**STAFF REPORT: 05-11-2022 MEETING**

**APPLICATION NUMBER: 22-7803**

**ADDRESS: 1201 WASHINGTON BOULEVARD**

**SCOPE: ERECT PENTHOUSES**

Applicant supplied photo, circa 1972. This picture shows altered storefronts.

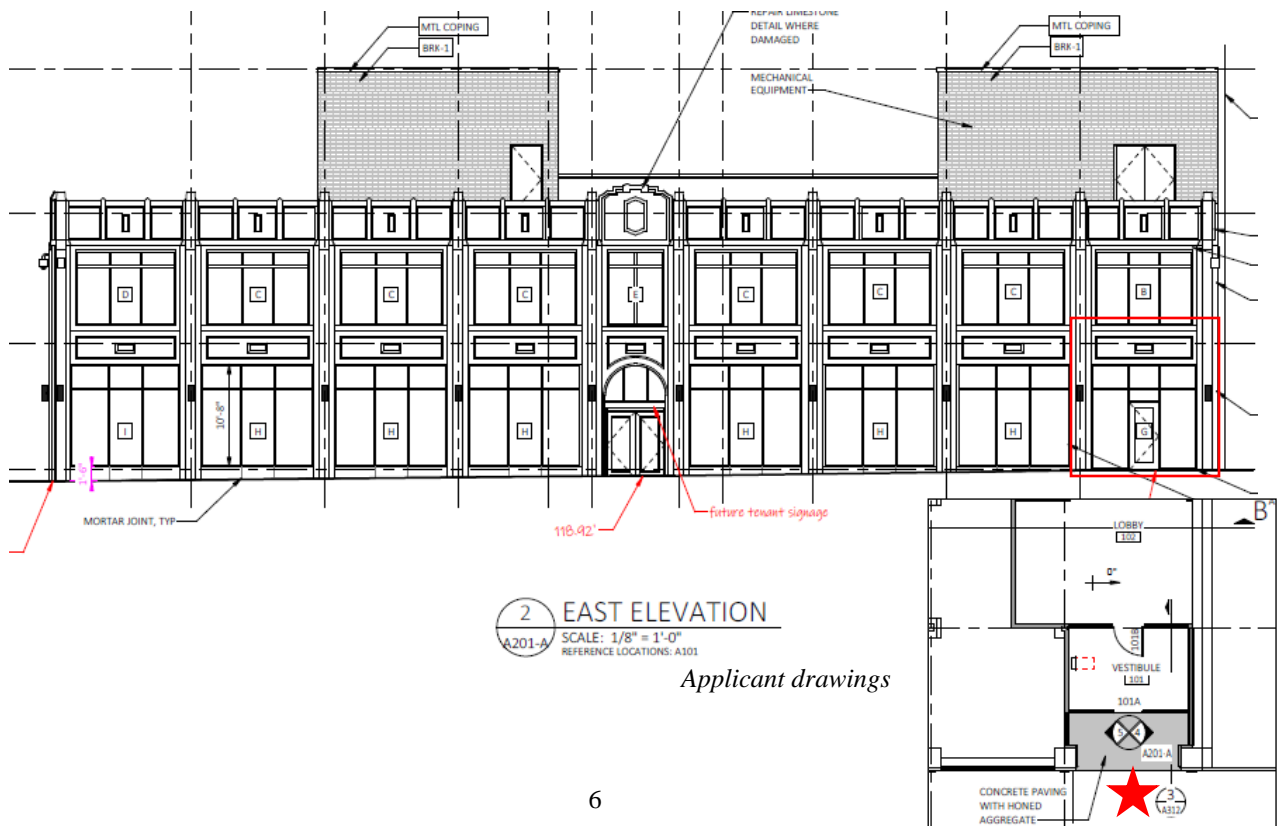
over time. As clear visual documentation of the original storefronts is not available, the selected minimally detailed storefront frame, divided to match the proportion of the existing vertical divisions within the historic limestone and second story transoms, is a sympathetic design.

- The removal of one flush storefront and introduction of a recessed entrance will offer a minimal impact to the building as the limestone walls and trim will remain intact, and the pattern of the recessed storefront and door will be identical to the remaining flush storefronts.

Applicant supplied section drawing. Staff is not clear as to the location of the lower roofed area.

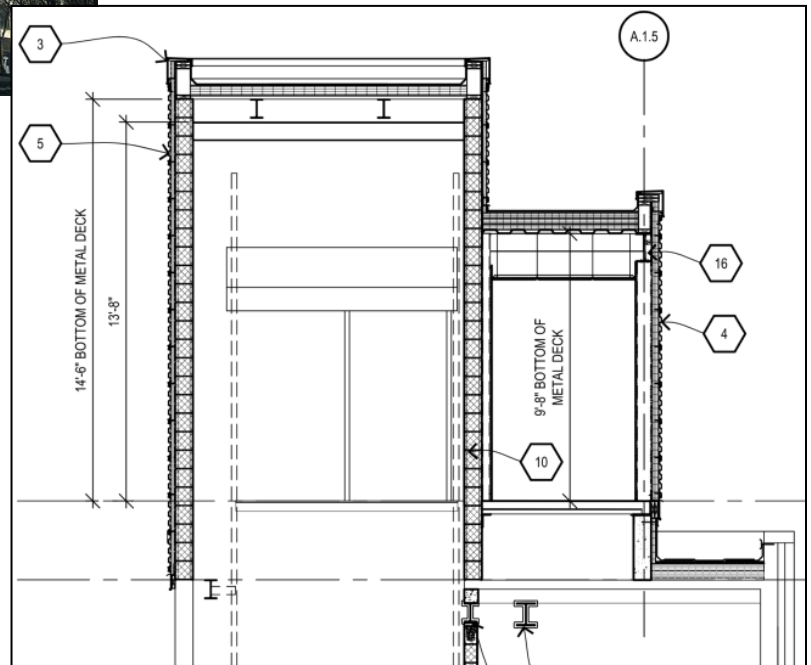
- The arcade building is approximately 26’ high and the penthouses heights are 15’, which is more than half the height of the building. Staff questioned the 15’ height (as the last two penthouses staff reviewed for other buildings were 11’ and 12’ tall), as well as the need for two sets of stairs to the roof of a two-story building. *Applicant response: The client would like to leave open the possibility of having a rooftop amenity/tenant space. In order to do so, two means of egress will be required, as will elevator access. The 15’ tall penthouse is to accommodate elevator overrun to access the roof level. A comparable project is the downtown Synagogue proposal (1445 Griswold). That penthouse is similar in height to this.*

- The height of the southern penthouse be reduced to the minimum clearance needed for a stairwell.
- Staff is granted authority to review the sidewalk plan for the remaining block, confirming that it will match the design approved within this application.

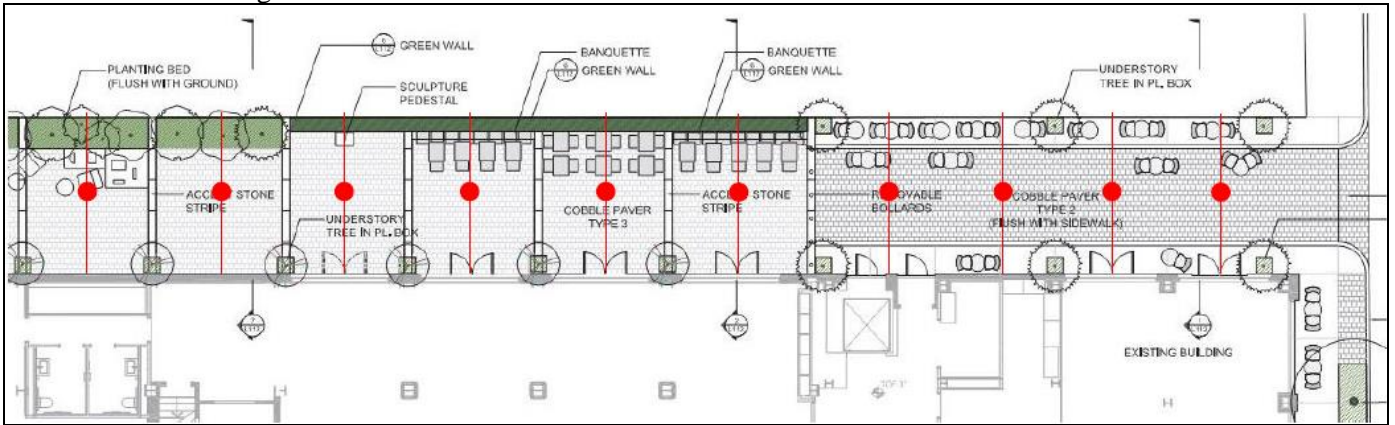
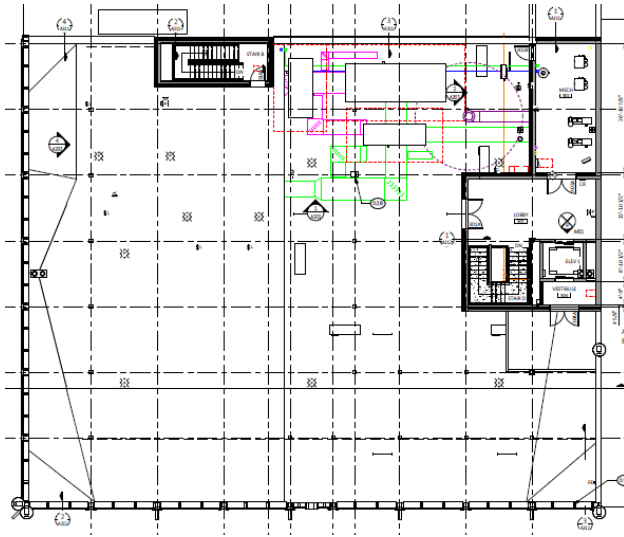
- As shown on the adjacent penthouse floor plan, the rear walls of both additions are in line with the rear/west wall of the building. The applicant's response to why a 15' height is needed for the elevator, it does not explain why the southern penthouse, which is a stairwell, is also at 15'. The east elevation, which shows both penthouses, is on page 6 of this staff report.

- It is common for rooftop structures to have varying heights and footprints. Therefore, staff believes it is more important that each penthouse be the minimal size/height required, rather than designing them to match each other.

OLD Plan - Revised Paving Plan on following page

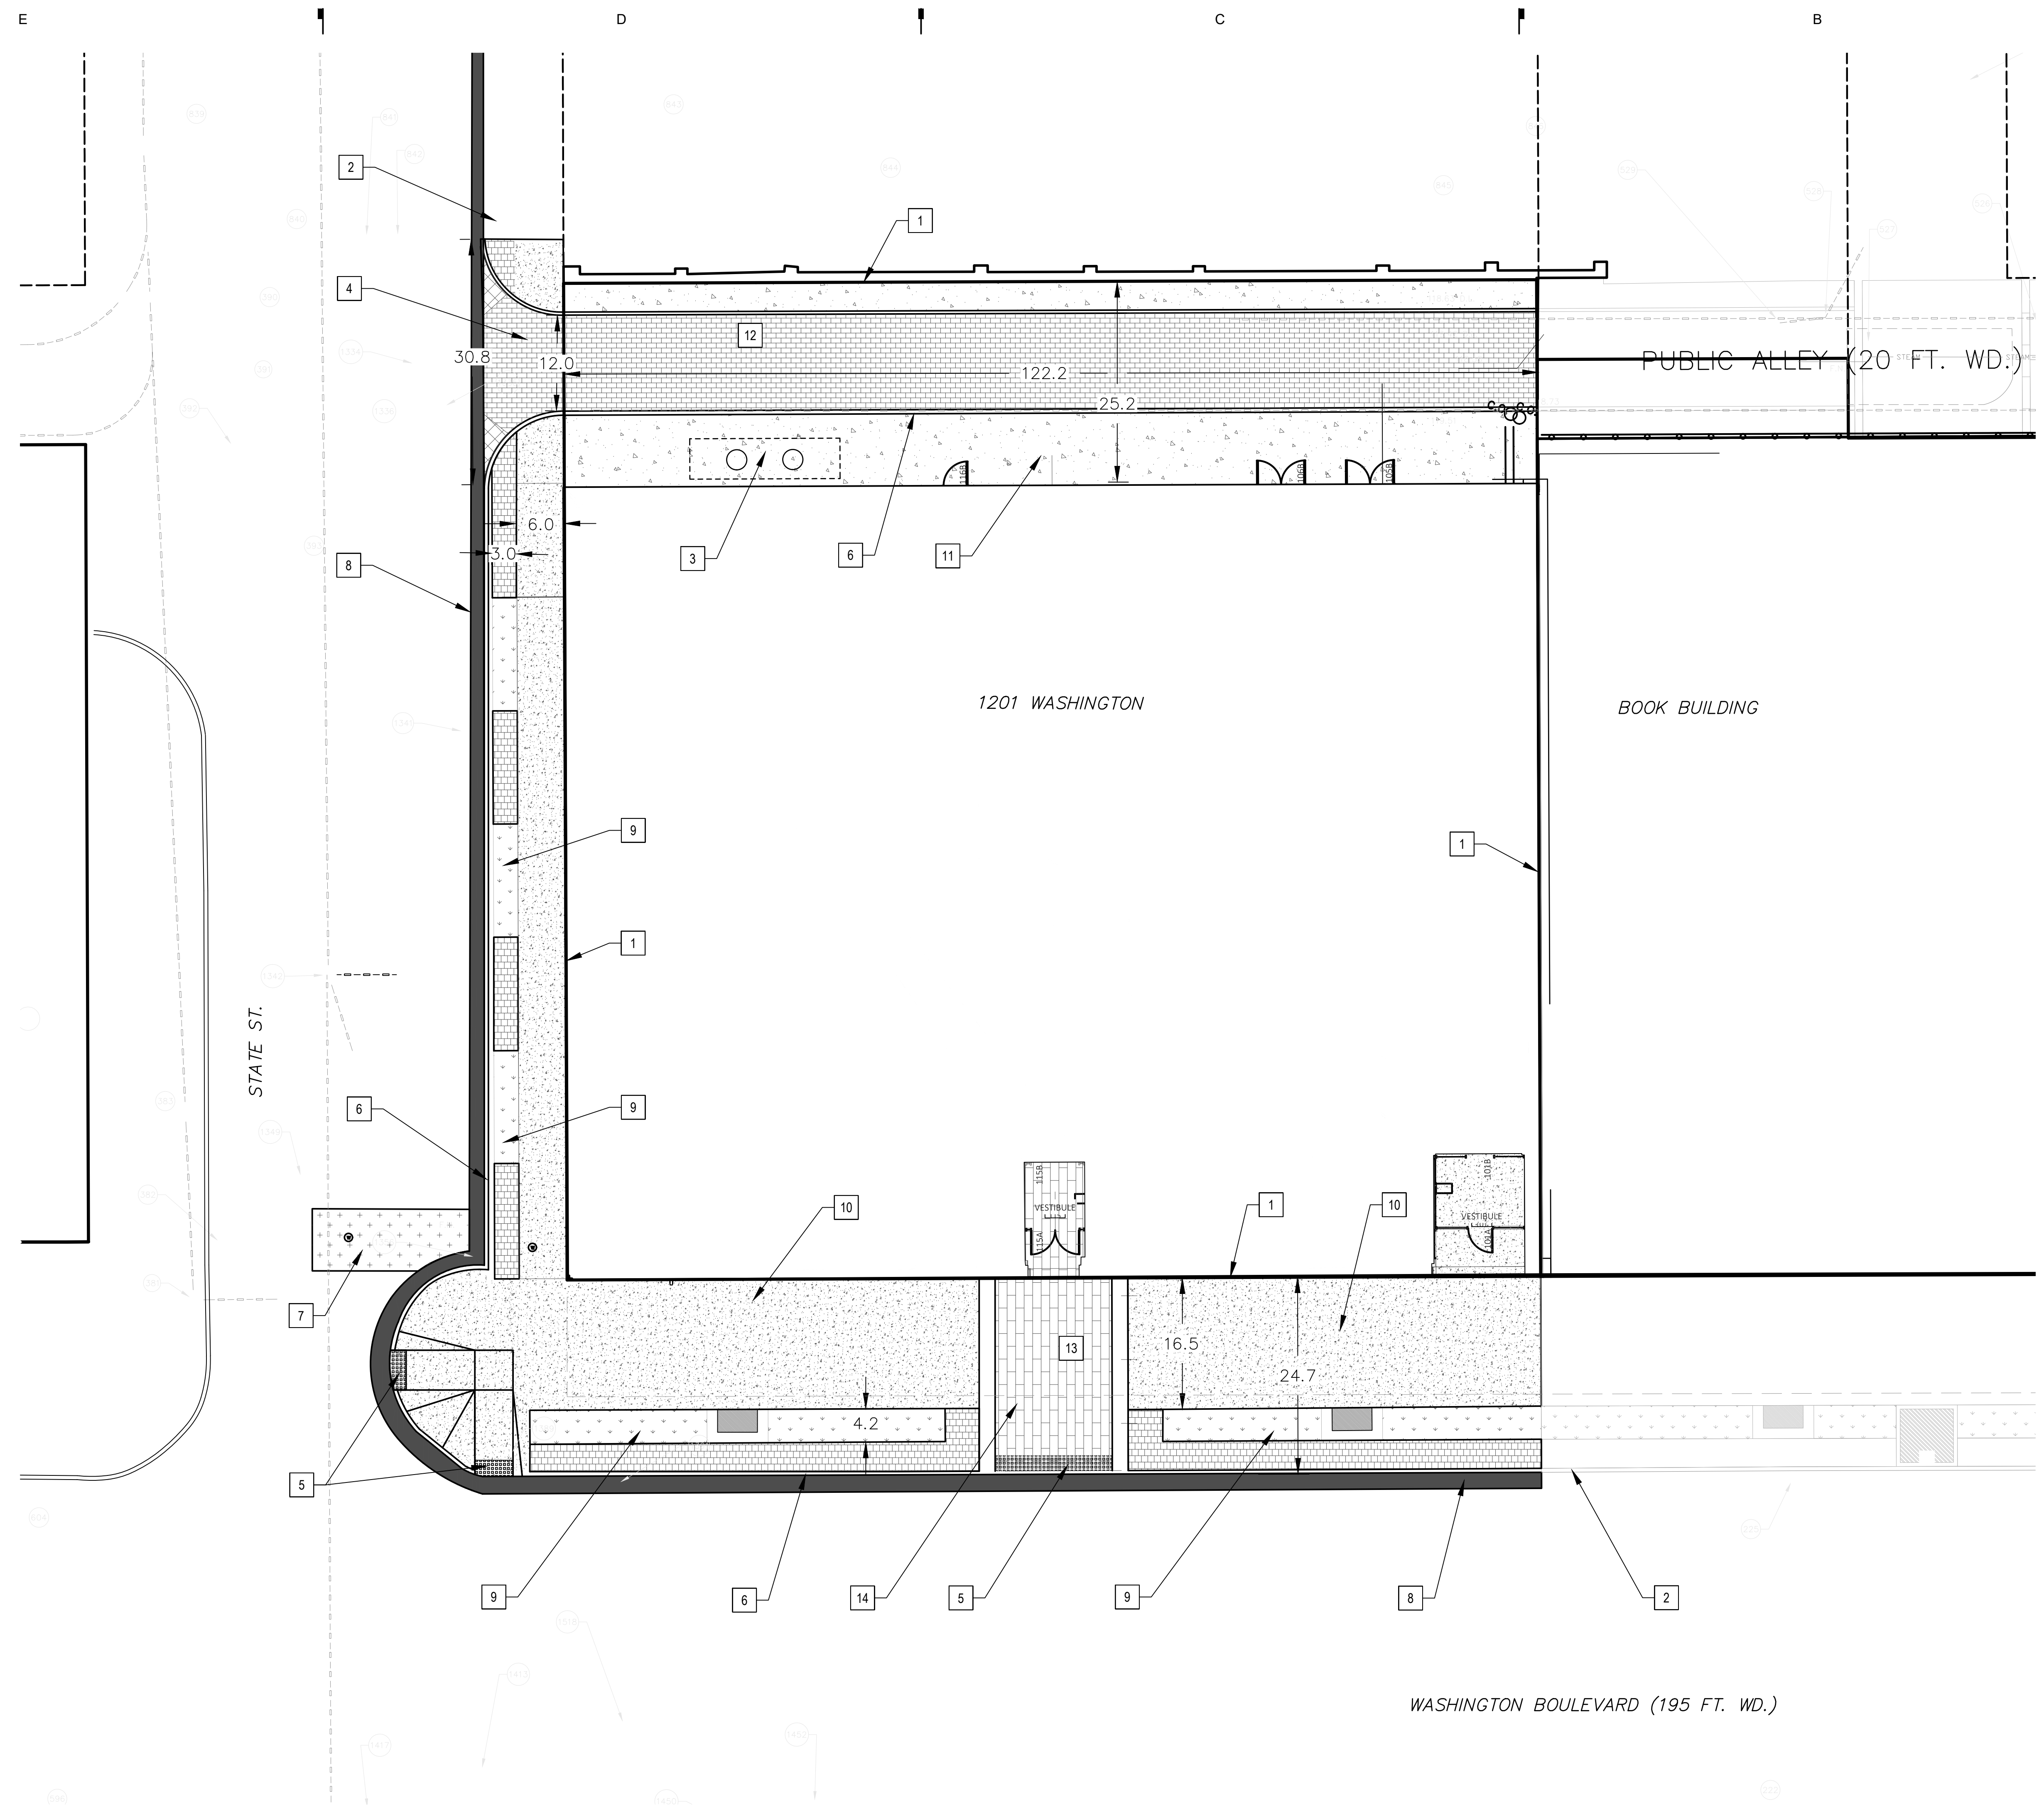
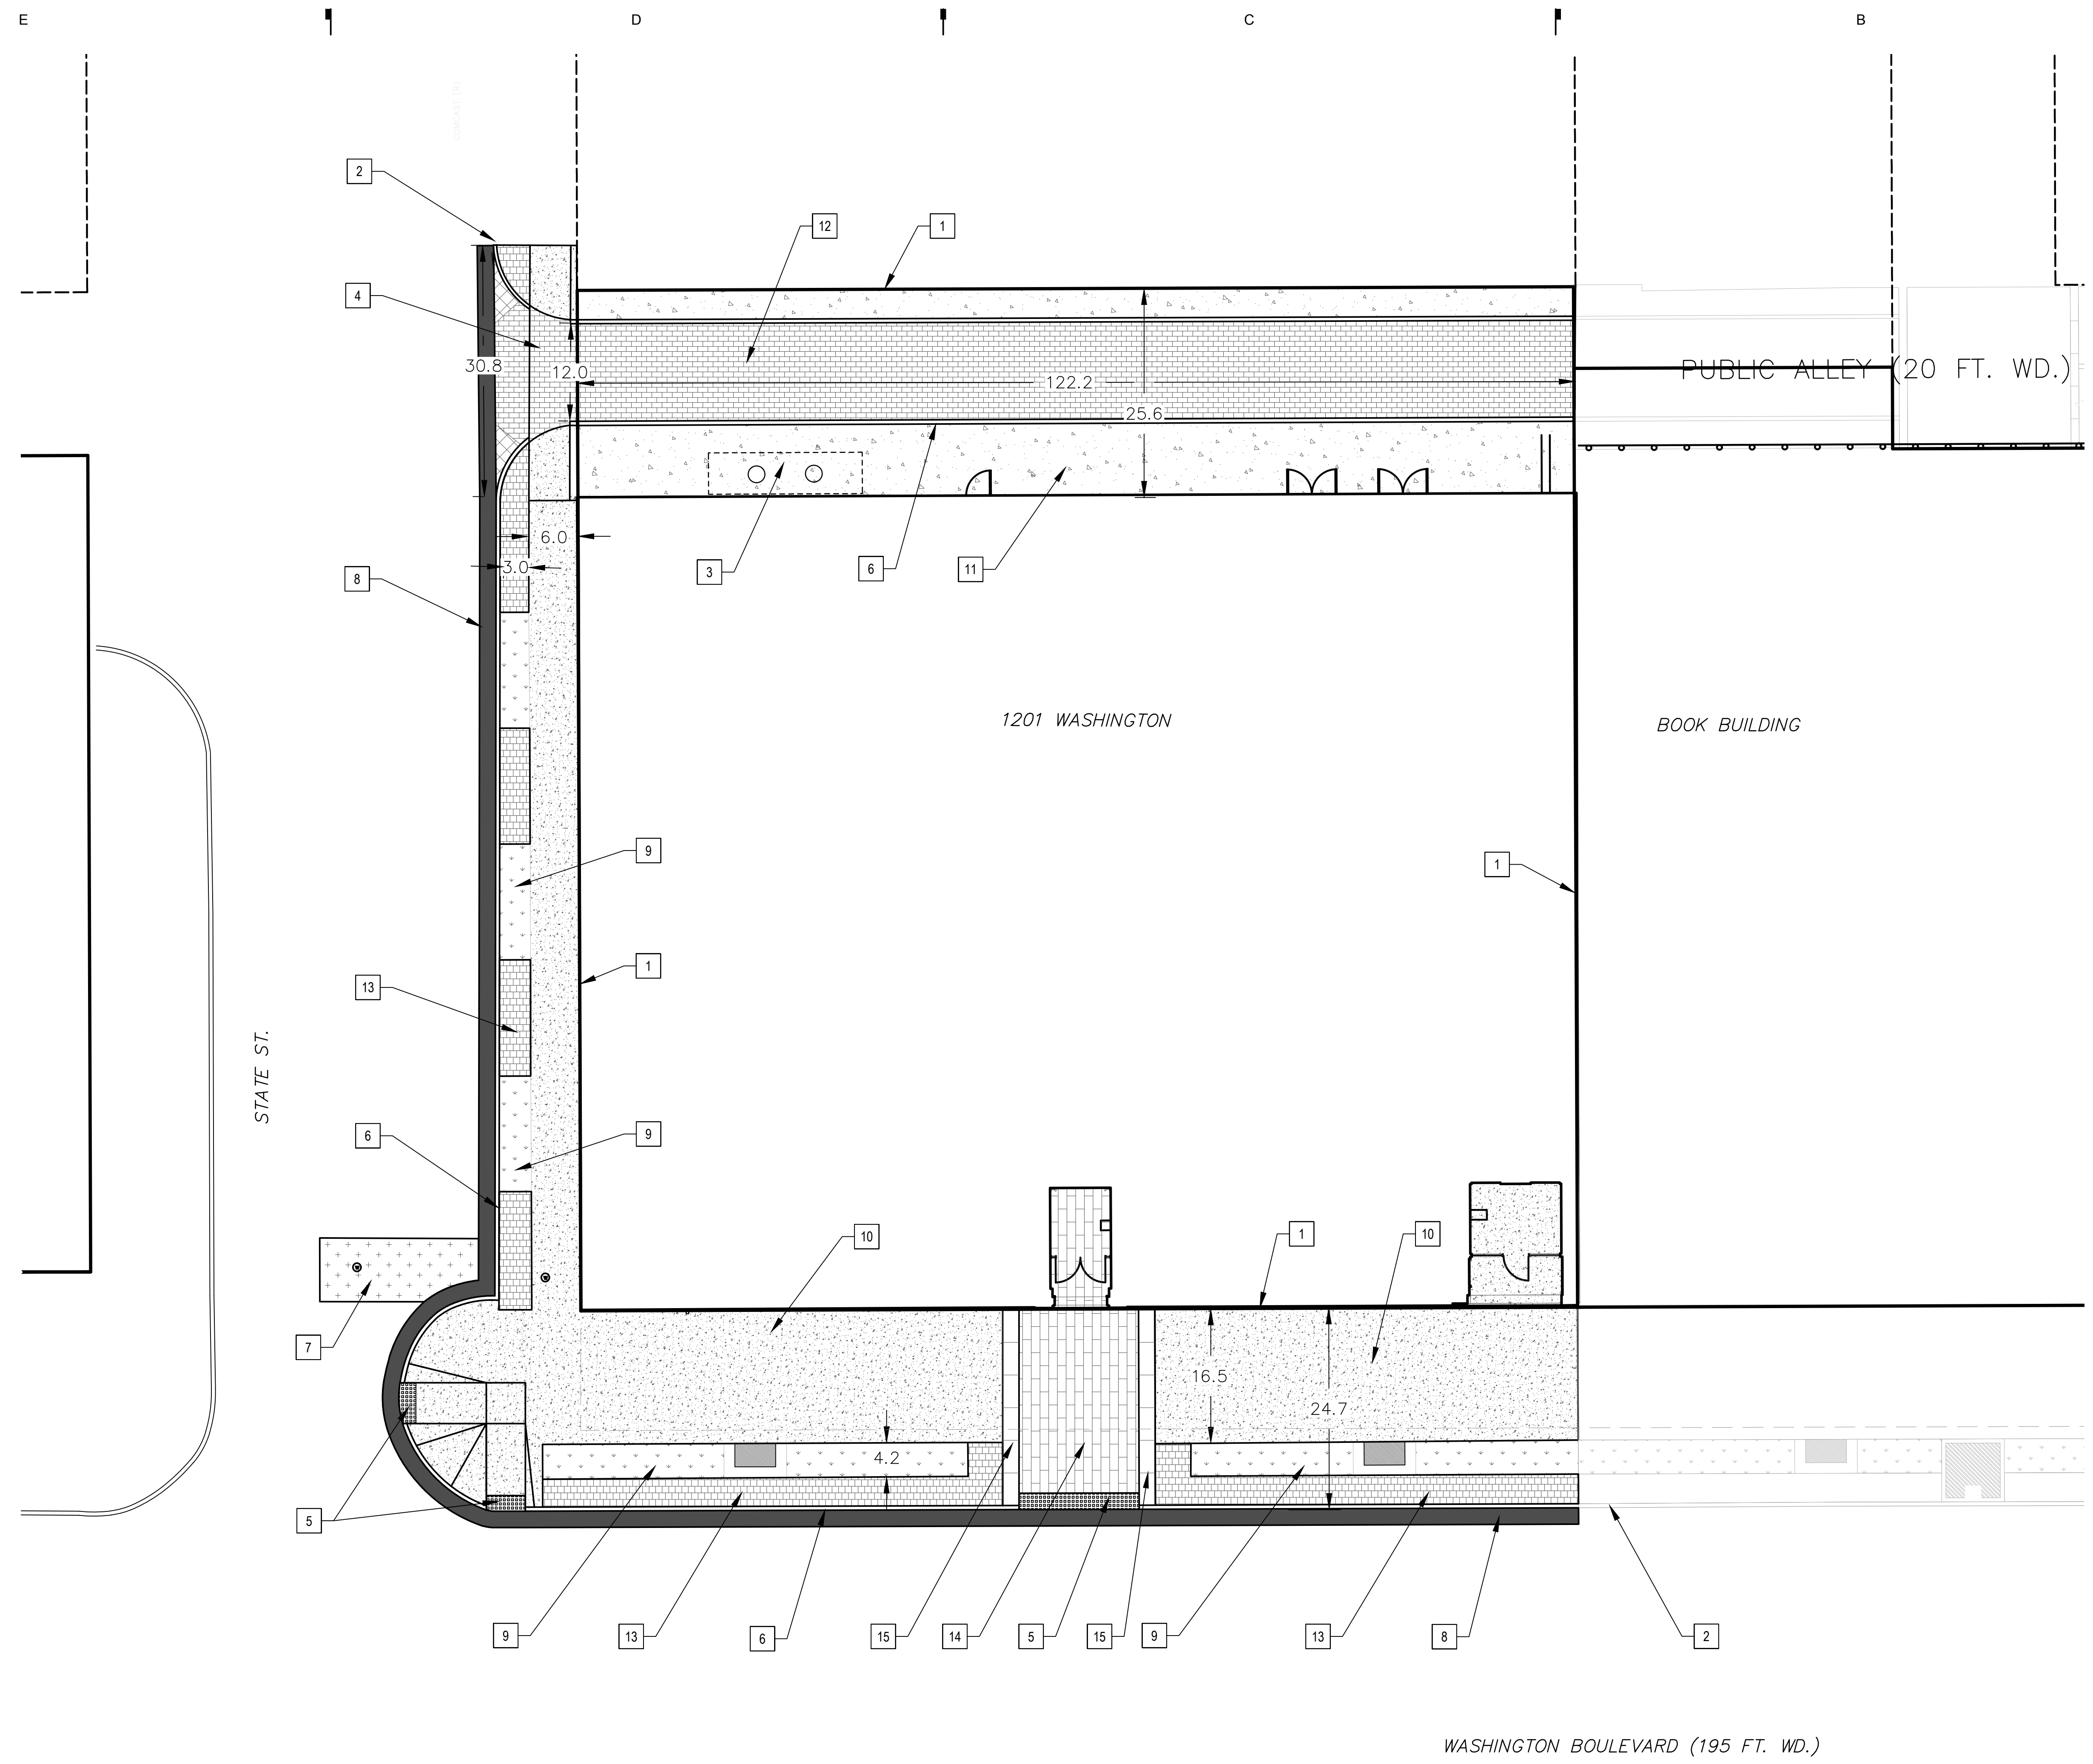
- In April 2020, the Commission reviewed and approved an alley design/paving materials as part of the Book Building and Tower rehabilitation, however the Commission did not review a sidewalk design as part of the project. Therefore, the sidewalk design proposed at 1201 Washington will be Commission's first review of the paving/landscape design for the block. The paving plan is found on Page C-400 in the drawing set; the visual examples of the paving materials can be found on the Site Materials page in the Product Info packet. At the time of the staff report, the Site Materials page had not been updated to correlate with the paving plan. The applicant submitted a rendering of the Book Tower entrance as an idea of the sidewalk design. It is staff's opinion the paving plan is neutral in design and color and is compatible with the historic character of the building.
